RESOLUTION

R28 – 2024

Certificate of Appropriateness for work in the Historic Districts:

**Historical Architectural Review Board
COA Final Review Sheet**

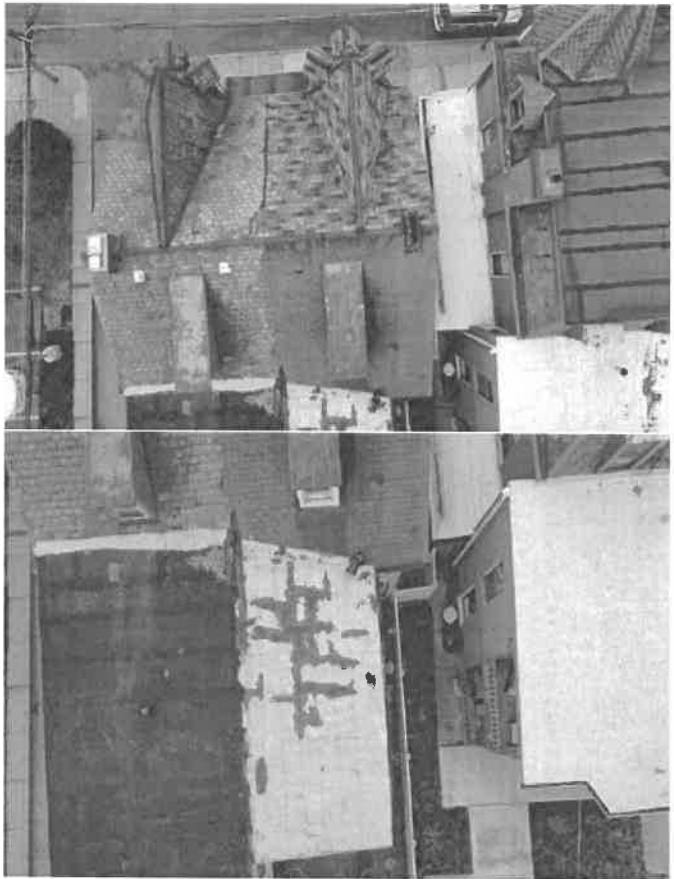
Observations & Comments: Google Streetview from 2014 shows slate roofing on the gable roof and tower roof but the later satellite views shows replacement shingle roofing. Rolled metal ridge caps are still on the roof. Replacement of existing asphalt shingles on the gable roof and tower roof with new GAF Slateline shingles in the Antique Slate color would be historically appropriate. New or refurbished rolled metal ridge caps should be installed on the roof edges of the tower roof and dormers. The existing historic finial must be retained, repaired in needed, and reinstalled. It is recommended to paint the rolled ridge caps and finial in a matching red color (Tinner's Rd)

Staff Recommendation: Recommend approval as submitted with the condition that metal rolled ridge caps are refurbished and reinstalled or replacement in-kind. The finial must be retained, repaired, and reinstalled.

Actions: Mr. AJ Jordan moved to approve, with conditions, the application presented on February 5th, 2024, to replace the roofing at 23 N 12th St with new GAF Slateline shingles, pursuant to Chapter 3.1. The following conditions were agreed to by the applicant:

- The existing metal rolled ridge caps will be refurbished and reinstalled or replaced in-kind
- The finial will be retained, refurbished, and reinstalled.
- Half round gutter will be installed with hangers appropriately mounted at the bottom of the sheathing
- Snow catchers will be retained and reinstalled
- A shingled cap will be installed at the joint between the neighboring roofs.

**Photo showing the windows and framing to be replaced.
(Google StreetView)**

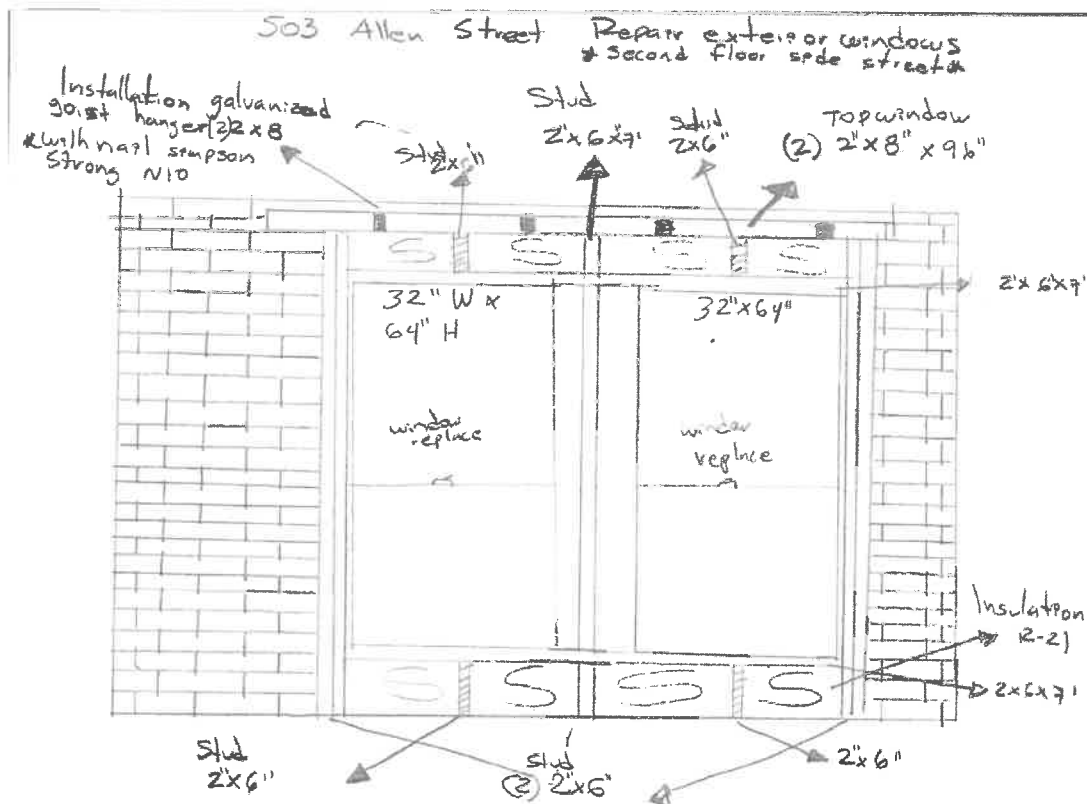
Staff notes that the building description from the time the district was designated describes the front façade windows as two-over-two double-hung sash windows with Italianate lintels. Staff suggests that the description is incorrect and contends that the building has Queen Anne features and that the windows were likely one-over-one double-hung sash windows.

At the time the applicant submitted the application, the second-story windows and framing had been removed without permits or a certificate of appropriateness. The drawing included in the application shows the interior framing and proposed window replacement. Staff initially rejected the drawing and requested an exterior drawing showing the framing and masonry opening; however, the applicant again provided the same drawing of the interior framing. Staff finds that the HARB cannot properly review the proposed scope of work without a drawing that shows the exterior framing, noting that the decorative trim below the lintel and the center mullion have been removed and should be recreated to their original dimensions and appearance to comply with Guideline 3.5.15.

If all exterior framing and trim is replicated to match the historic, staff finds the proposed aluminum-clad wood sash windows to be appropriate, provided they are the same dimensions as the historic windows.

Denial, owing to incompleteness, with the comment that a scaled elevation drawing of the exterior framing, trim, and masonry opening be submitted for HARB review.

Mr. AJ Jordan moved to approve, with conditions, the application presented on February 5th, 2024, to replace the historic windows and framing with new aluminum-clad wood windows and wood framing, pursuant to Chapter 3.5, sections 3.5.8, 3.5.9, 3.5.15. The following conditions were agreed to by the applicant:

- The exterior trim will be 1” thick, flat, rot resistant wood (not pressure-treated and not capped in aluminum)
- The sill will be a 4”-5” above the roof surface to the bottom and would be appropriately flashed from under the sill to the roof.
- The sill would be 3”-4” thick and made of rot resistant wood (not pressure treated and not capped in aluminum).
- The carved arched header piece will be reinstalled.
- The unique “keystone” details will be replicated.
- The window replacements are aluminum clad wood as proposed.
